# FIELD SERVICE BULLETIN

FSB Number	FLCCFSB2007 - 310/Rev2
Author	Oke Christiansen
Date	Tuesday, January 15, 2008
Subject	<b>CDMA GSM - MOTORAZR2 V9m MOTORAZR<sup>2</sup> V8 - Missing Battery Insulator Tape</b>
Model Affected	All
Level Of Repairs	2

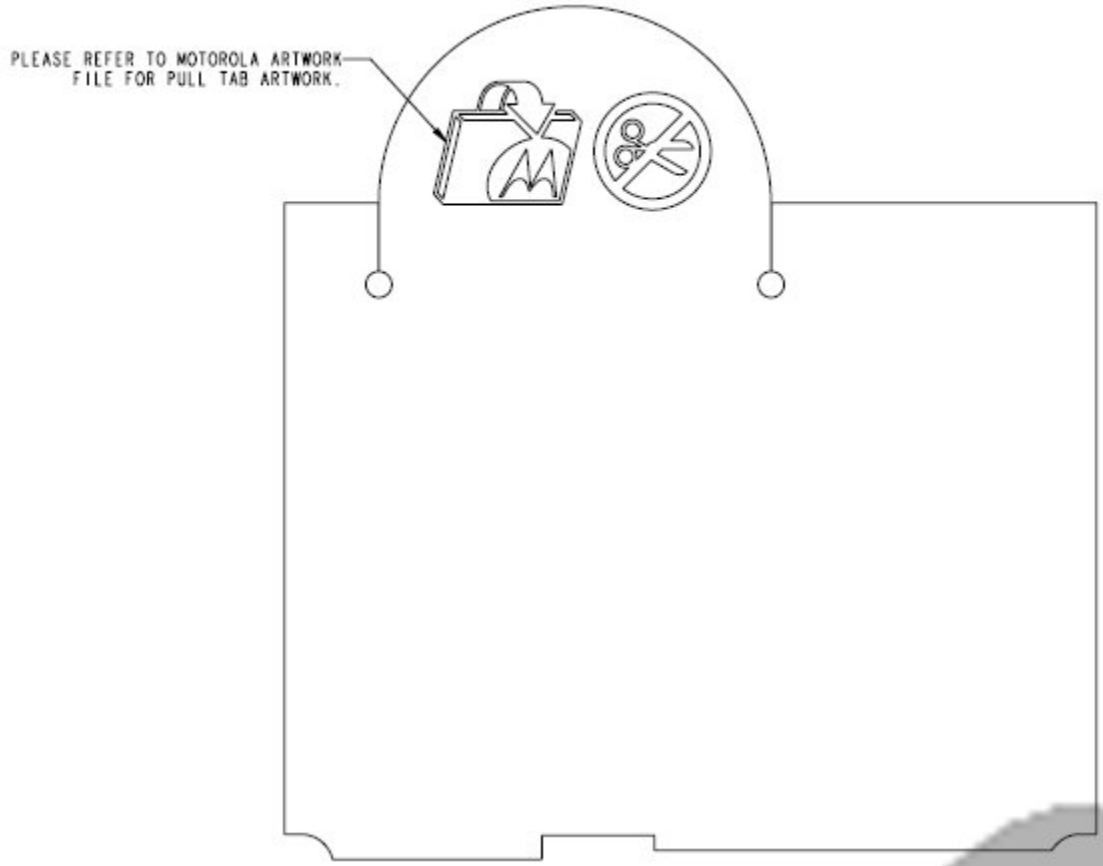
Service is aware of an issue identified in the NPI Analysis of the CDMA MOTORAZR<sup>2</sup> V9m, alongside GSM MOTORAZR<sup>2</sup> V8. Some units, returned with several customer complaints, showed a missing or damaged Battery Insulator Tape.

The root cause of the missing or damaged label seems to be that Customers did not understand the use of the latch at the Battery Insulator Tape. After inserting the battery and assembling the battery door, the latch is looking out of the housing. So they decide to rip the latch off. In some cases they ripped the whole tape of the phone which will also cause that the IMEI/ESN and factory labels are missing.

Graphics will be added to the Battery Insulator Label to make the use of the latch visible to the end users.

The additional artwork to the label has been approved and all current label production has switched over to it. This CA will not prevent that the consumer rip of the label, but it will advise him the purpose of the foil latch.
